TMS320VC5421
Digital Signal Processor
Silicon Errata

SPRZ170C
April 2000
Revised October 2001

Figure 3. Shared-Memory Map

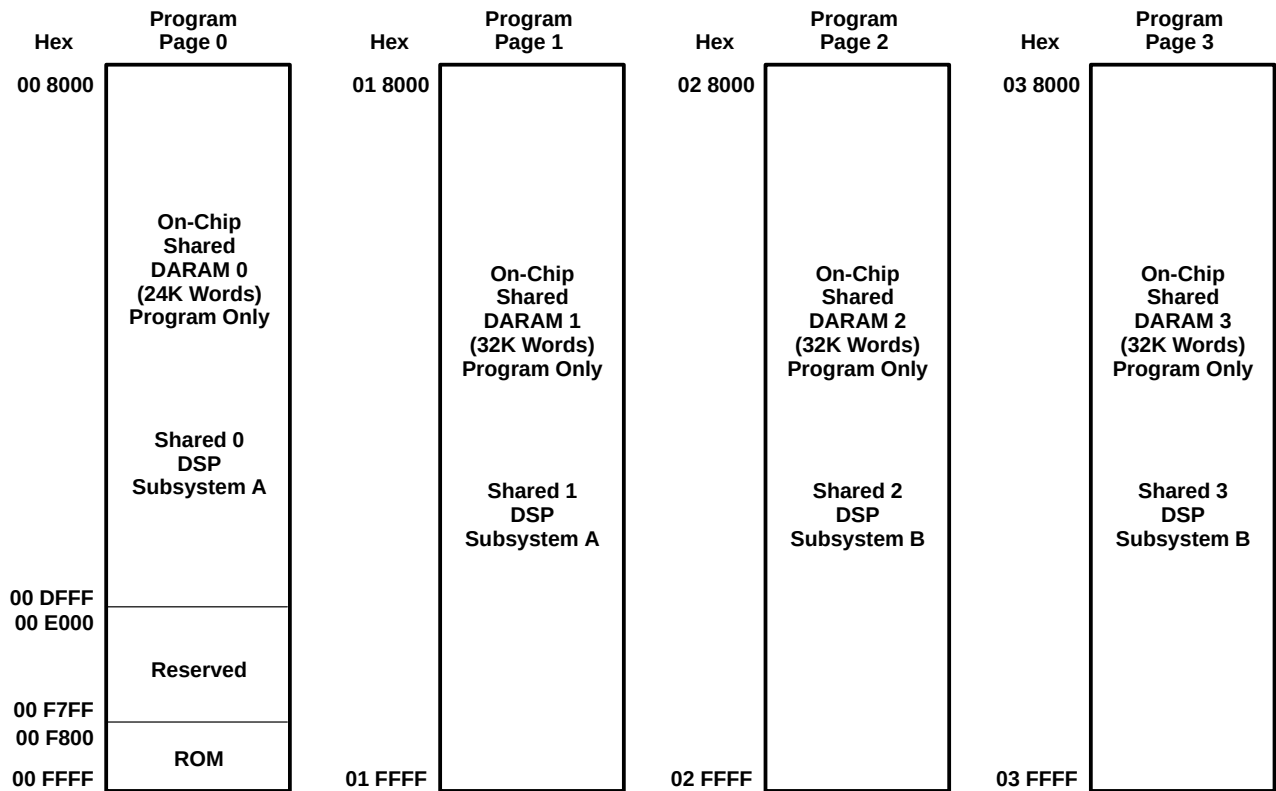
Details: When a 5421 subsystem is halted in emulation mode, the other subsystem is unable to access the shared memory associated with the halted subsystem (see Figure 3 for the shared-memory map). This also affects the use of software and hardware breakpoints in the shared memory. Note that this issue only affects the TMX320VC5421 during emulation, and there are no issues with shared memory accesses during normal functional mode.

Workaround: None. This problem is corrected in Revision A silicon.

Figure 3. Shared-Memory Map

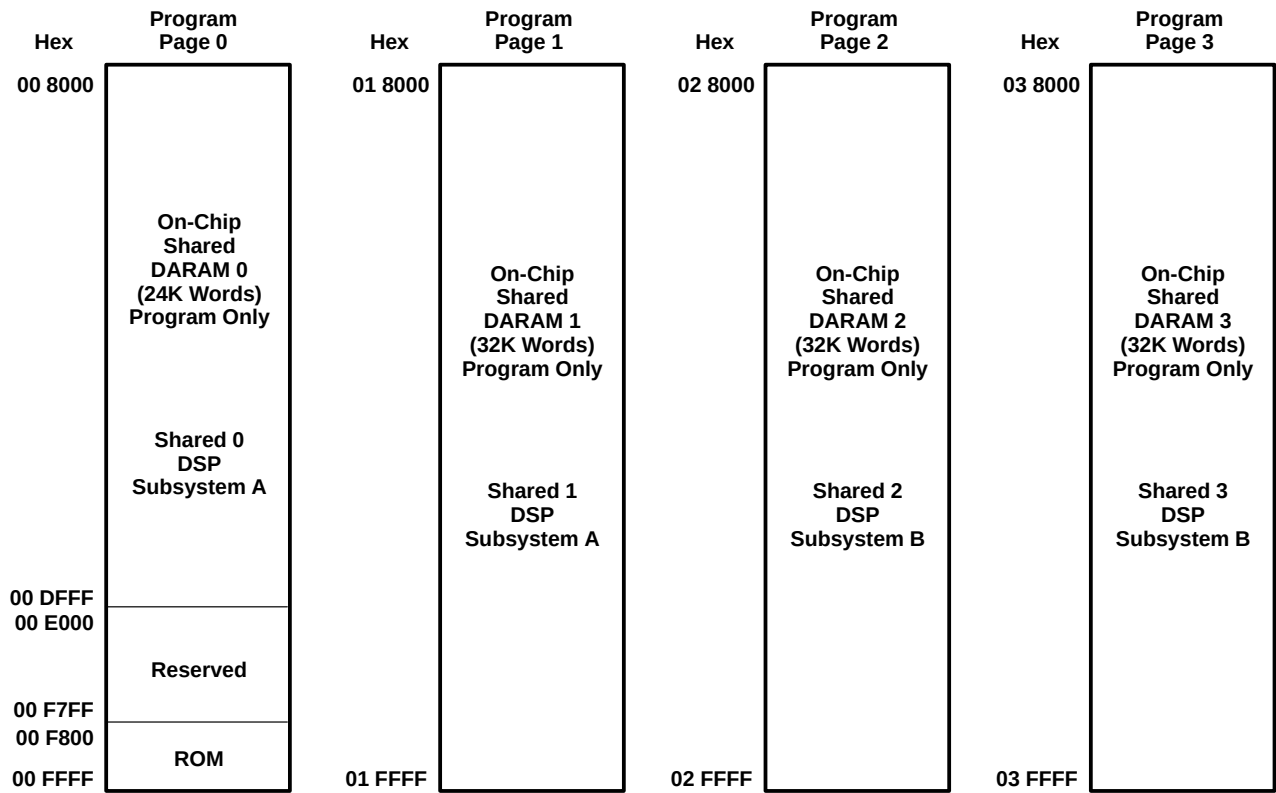
Details: When a 5421 subsystem is halted in emulation mode, the other subsystem is unable to access the shared memory associated with the halted subsystem (see Figure 3 for the shared-memory map). This also affects the use of software and hardware breakpoints in the shared memory. Note that this issue only affects the TMX320VC5421 during emulation, and there are no issues with shared memory accesses during normal functional mode.

Workaround: None. This problem is corrected in Revision A silicon.
